ALEXAN MONTROSE CROSSING

OVERALL LANDSCAPE EXHIBIT

ALEXAN MONROSE CROSSING
 ROCKVILLE (4TH) ELECTION DISTRICT
 MONTGOMERY COUNTY, MARYLAND

FINDINGS: For Site Plan Review

WEST ELEVATION

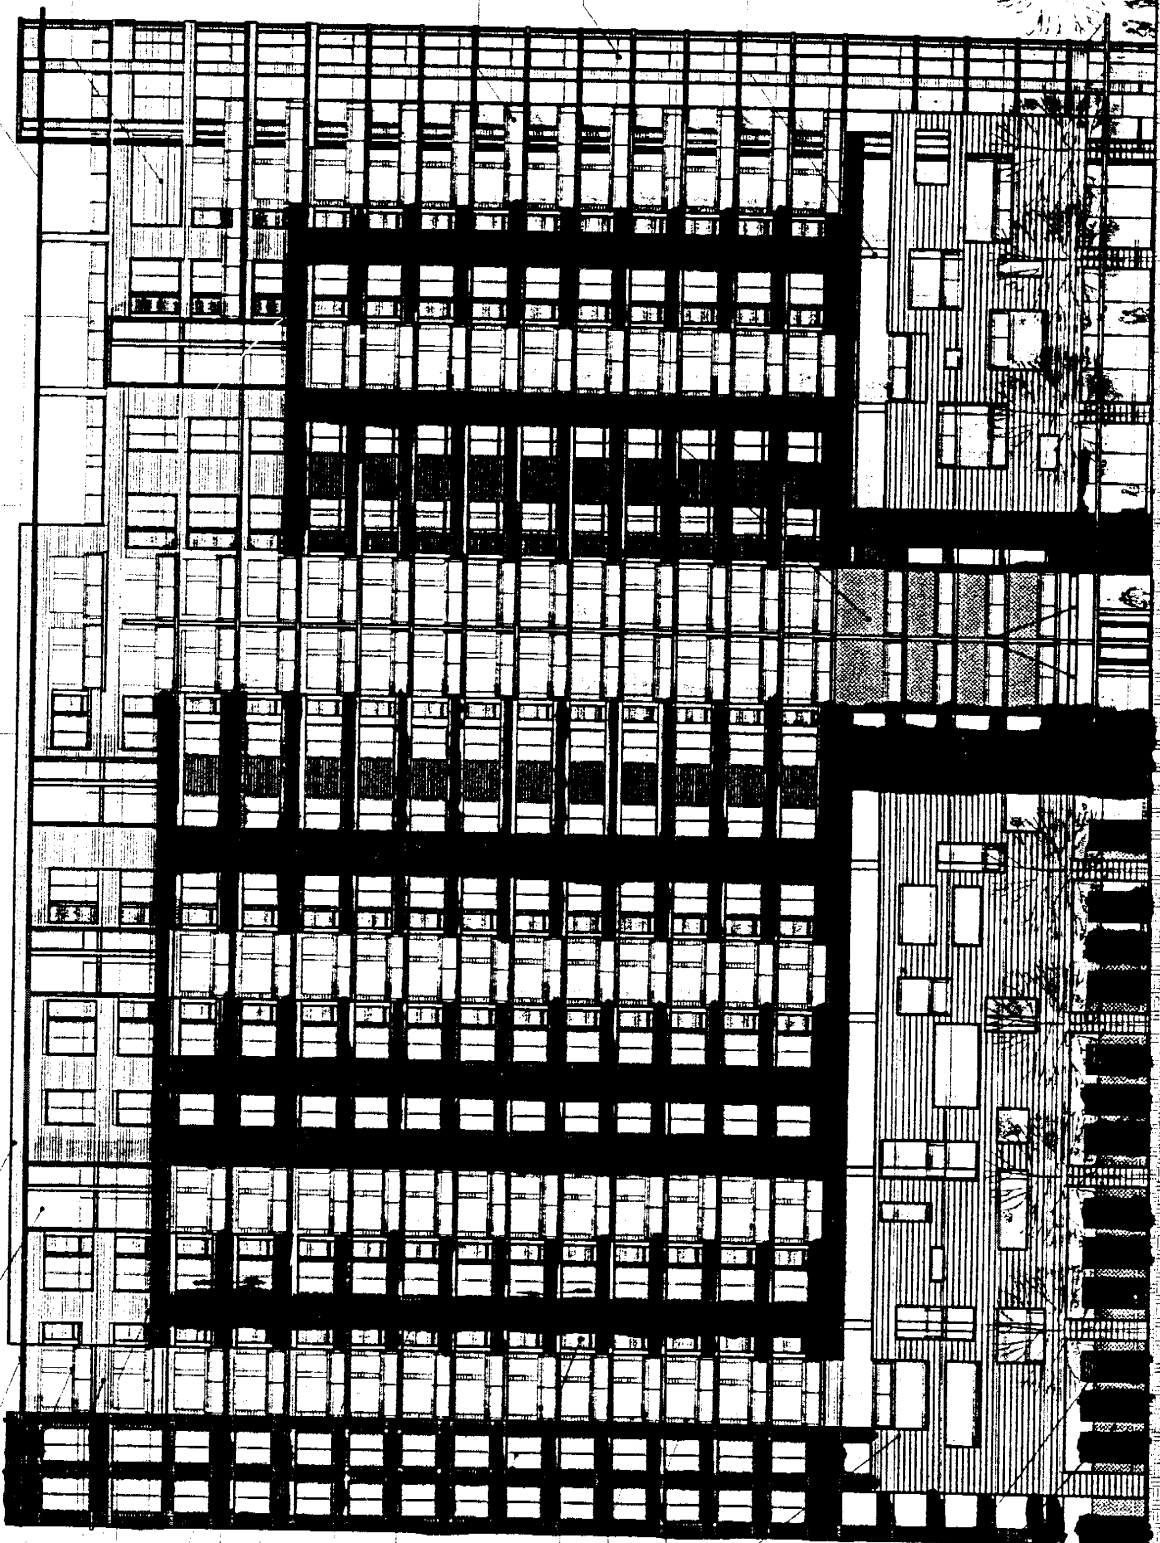
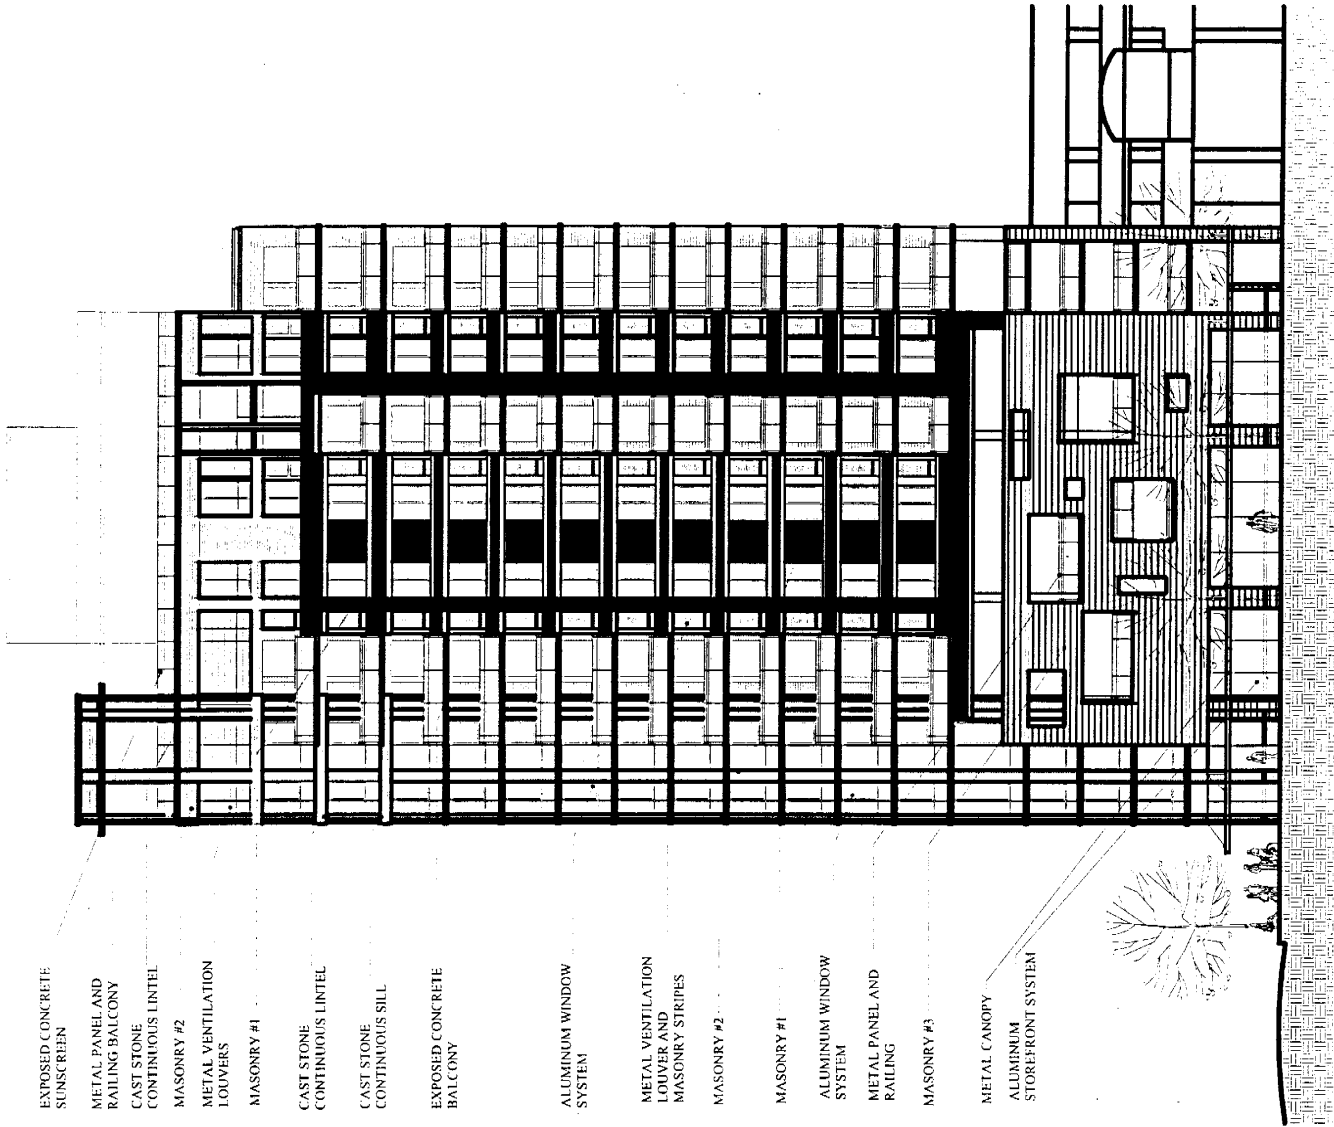
The view of the parking levels needs to be buffered from views at the street to buffer views of cars and lights that are potentially on all night. The final site plan shall include the appropriate treatment for staff review.
